APPLICATION FOR A RESIDENTIAL SITE IMPROVEMENT PERMIT/ CONSTRUCTION AUTHORIZATION FOR AN ON-SITE WASTEWATER SYSTEM, NEW WELL INSTALLATION, OR REPAIR OF EXISTING WELL

SOIL/SITE EVALUATION
for ON-SITE WASTEWATER SYSTEM

IMPROVEMENT PERMIT DENIAL

Re: Application for Improvement Permit for property located at 4509 WOODLAND AV , MINT HILL, NC 28227
Parcel No.: 13711270
Health Department File No.: SP26-097

PROPOSED PLOT PLAN

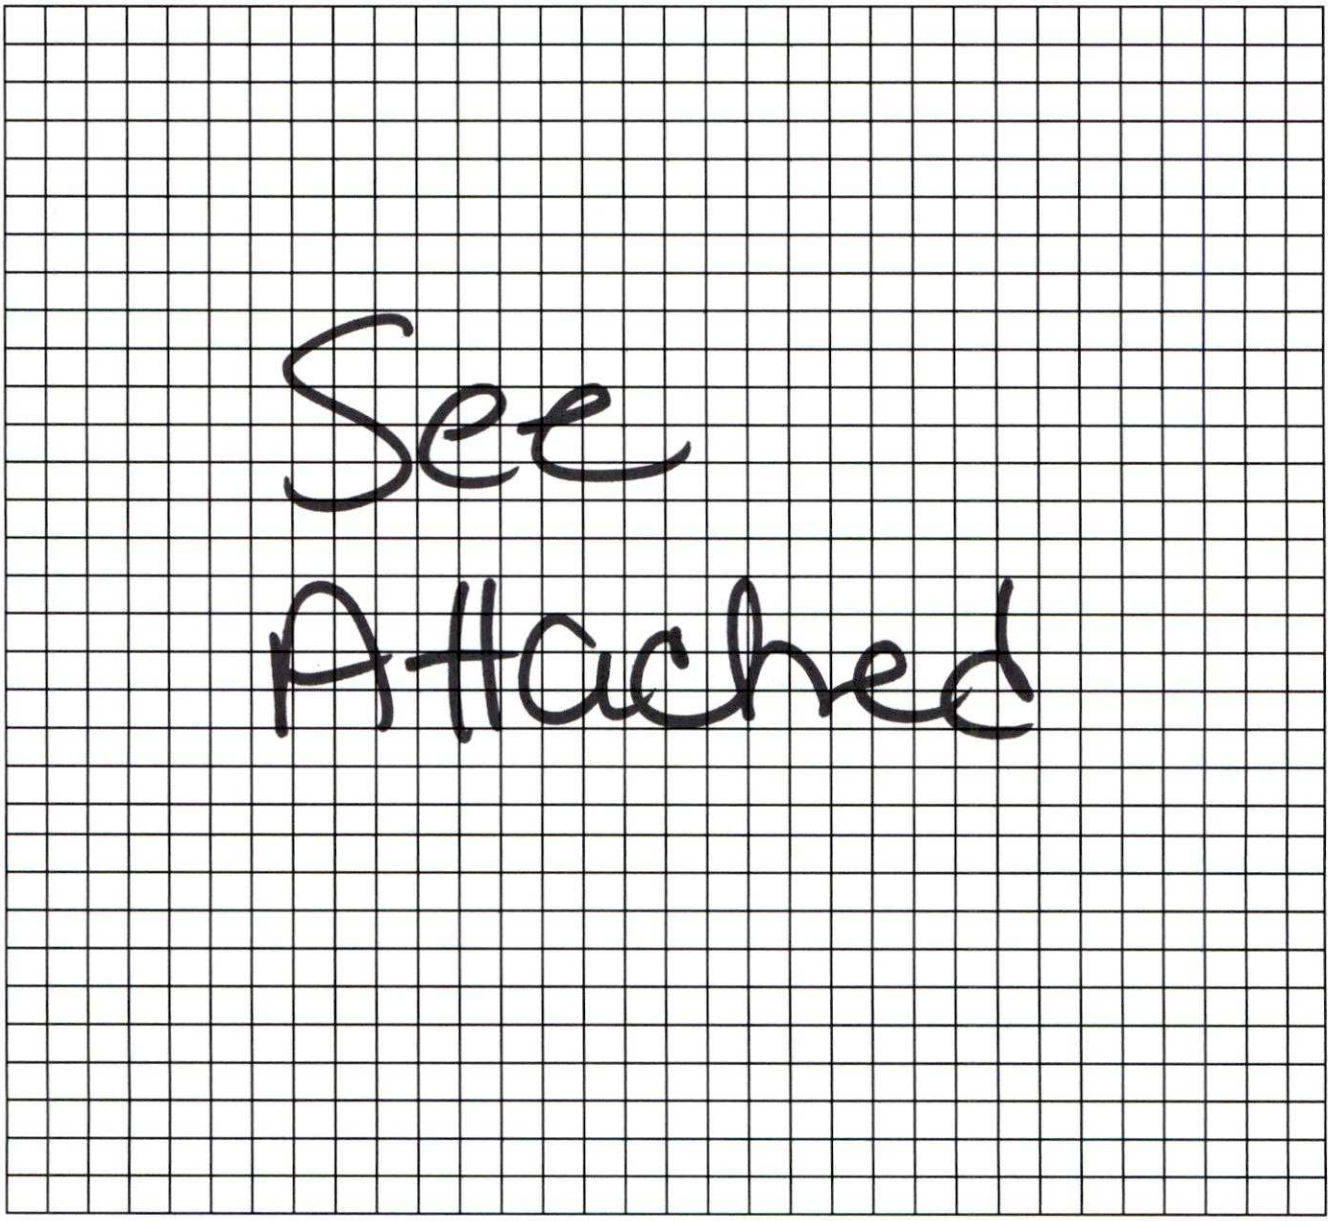
COMMENTS: There is insufficient space for a 5 BR SFR initial system and repair area with a design LTAR of 0.30.

Based on the criteria set out in 15A NCAC 18E .0501 through .0602, the evaluation indicated that the site is **UNSUITABLE** for an on-site wastewater system. Therefore, we must deny your request for an Improvement Permit. A copy of the site evaluation is enclosed. The site is unsuitable based on the following:

The site evaluation included consideration of possible site modifications, as well as use of all possible systems approved under 15A NCAC 18E. However, the Health Department has determined that none of the above options will overcome the severe conditions on this site. A possible option might be a system designed to dispose of sewage to another area of suitable soil such as off-site to additional property.
